Varimixer

New shape

Standardization of knee and foot design across AR30, AR40 and AR60 variants

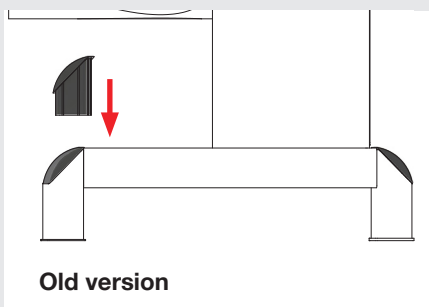
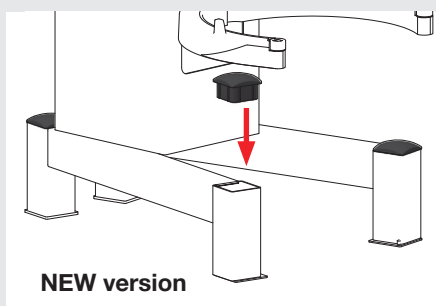
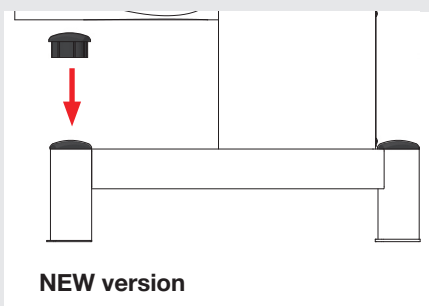
To improve the quality of the plastic knee component through updated mould tooling and a revised design. The new design also provides better coverage of the foot, reducing the risk of water ingress. In addition, the knee and foot design has been standardized across AR30, AR40 and AR60 stands, reducing part variation and simplifying inventory management.

Previously, AR30/40 and AR60 used different component designs. The new common design replaces the previous variants, reducing part complexity and simplifying production, inventory management and service support. Production kits and related BOM structures have been updated accordingly.
